SI B11 11 18
Engine

SERVICE ACTION: N63R ENGINE – CHECK AND REPLACE VANOS ACTUATORS, OIL FEED LINES, CHARGE AIR COOLERS AND THE MAP THERMOSTAT ELECTRICAL CONNECTOR

This Service Information bulletin replaces SI B11 11 18 **dated October 2018**

Turbocharger oil feed line overview:	The oil feed line locations are shown with red highlight
--------------------------------------	--

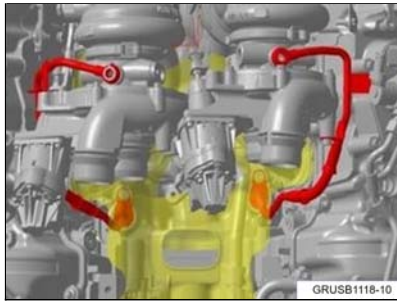
1. (Stainless steel flexible section. This is the new design and should not be replaced.

2. Black rubber flexible section. This line should be replaced.

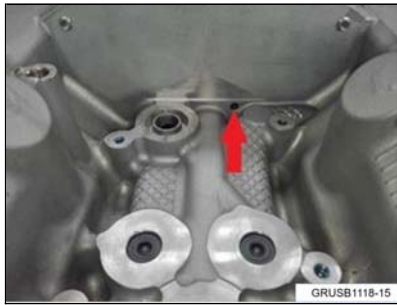
3. Check the exhaust turbocharger oil feed line on bank 2.

If the flexible section of the feed line is made of braided stainless steel (see arrows) then take no further action. **Do not replace the line.**

If the flexible section is black rubber then the oil feed line will need to be replaced.

UPDATE! Refer to Repair Instruction 11 42 200 “Remove and install / renew the oil feed line for the exhaust turbocharger N63O2”
Do not remove the turbochargers!

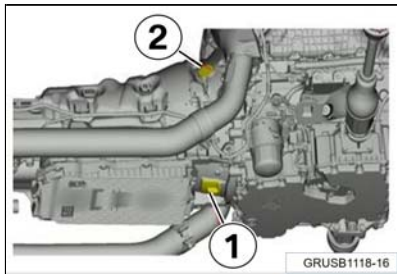
Check the engine block (V-space) for engine oil residue and clean as needed.

If there is leakage, the exhaust system, both exhaust turbochargers, the lower heat shield, the complete exhaust manifold and the oil-to-coolant heat exchanger needs to be removed to clean this area.

Wipe dry with a shop towel and rinse the residual oil with cleaner via the drain hole and flush it out (see arrow).

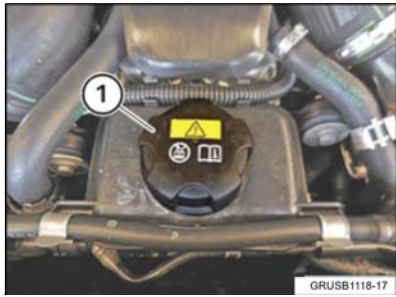
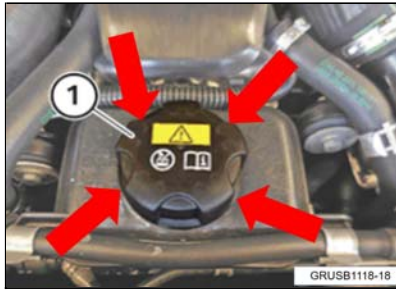
1. Locate and inspect the low temperature cooling system cap (1) for traces of overflowing.

2. Do not remove the cap, if there are traces of wet or dried coolant around the cap surface then it is overflowing.

If found overflowing, replace both charge air intercoolers.

If not leaking, do not replace any parts and do not drain the cooling system.

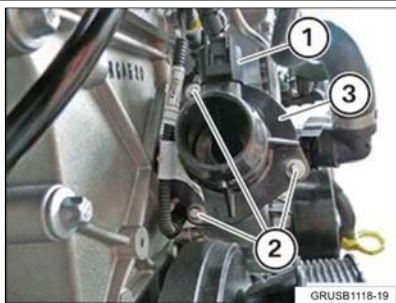
1. Locate the Map Thermostat Electrical Connector (1).

2. Remove the connector and check the pins in the connector for traces of water or corrosion.

Example: This connector is already corroded.

If the pins in the connector are corroded, the engine wiring harness and the characteristic map thermostat need to be replaced.
